Outer Optical Modulation Amplitude and Average Launch Power (In support of comments #13, #14, and #15)

Eric Bernier, Limin Geng (Huawei)

May 12th, 2026

Comments against P802.3ds draft D1.0

Consideration on OMA_{max}

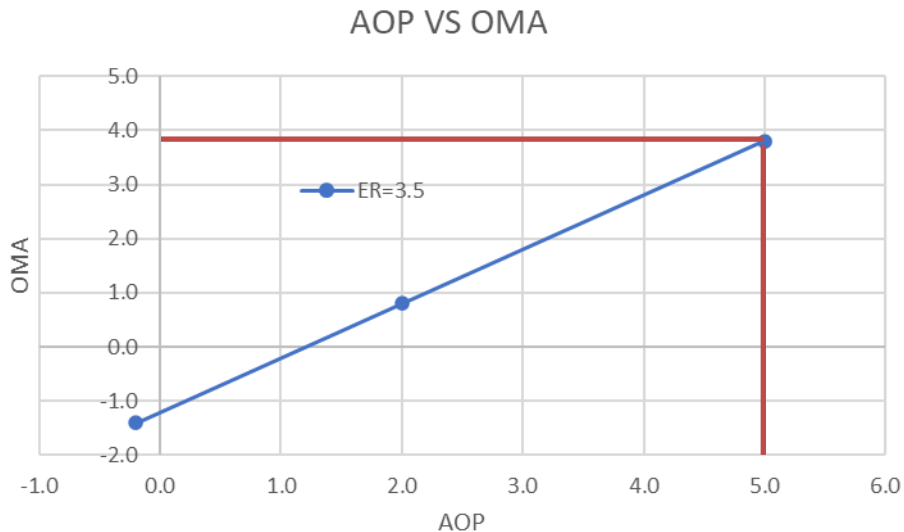
- Compared with 802.3df, 802.3ds Baseline AOP_{max} is increased by 1 dB, but OMA_{max} remains unchanged.
- Calculated based on AOP and OMA conversion formula, OMA is 3.8dBm corresponding to AOP 5dBm, which is exceed the OMA max spec 3.5dBm
 - Propose setting Tx OMA_{max} specification as 3.8dBm
